#### **Addendum 128 – UN Regulation No. 129**

#### **Revision 1 - Amendment 7**

Supplement 6 to the 01 series of amendments – Date of entry into force: 11 January 2020

#### **Uniform provisions concerning the approval of Enhanced Child Restraint Systems used on board of motor vehicles**

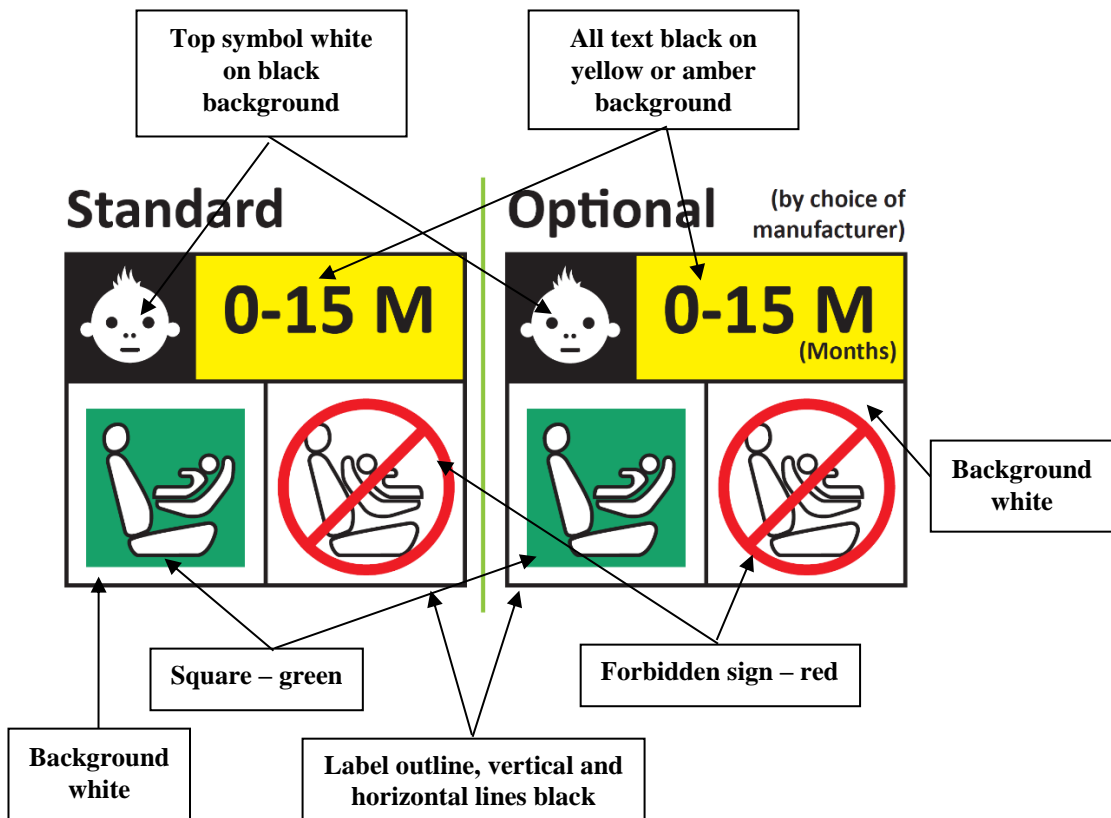
Paragraph 4.5., amend to read:

"4.5. Integral Enhanced Child Restraint Systems that can be used forward and rearward facing, shall have the following label permanently attached on the part hosting the child and visible to the person installing an Enhanced Child Restraint System in the vehicle:

The manufacturer shall be permitted to include the word "months" to explain the symbol "M" in the label. The word "months" should be in a language commonly spoken in the country or countries where the product is sold. More than one language is allowed.

Minimum label size 40 x 40 mm

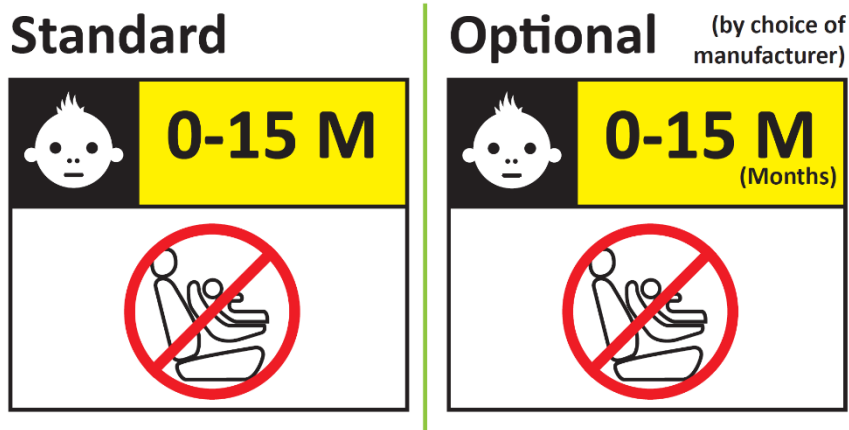
Integral Enhanced Child Restraint Systems that can be used forward facing only shall have the following label permanently attached on the part hosting the child and visible to the person installing an Enhanced Child Restraint System in the vehicle:

The manufacturer shall be permitted to include the word "months" to explain the symbol "M" in the label. The word "months" should be in a language commonly spoken in the country or countries where the product is sold. More than one language is allowed.

Minimum label size 40 x 40 mm
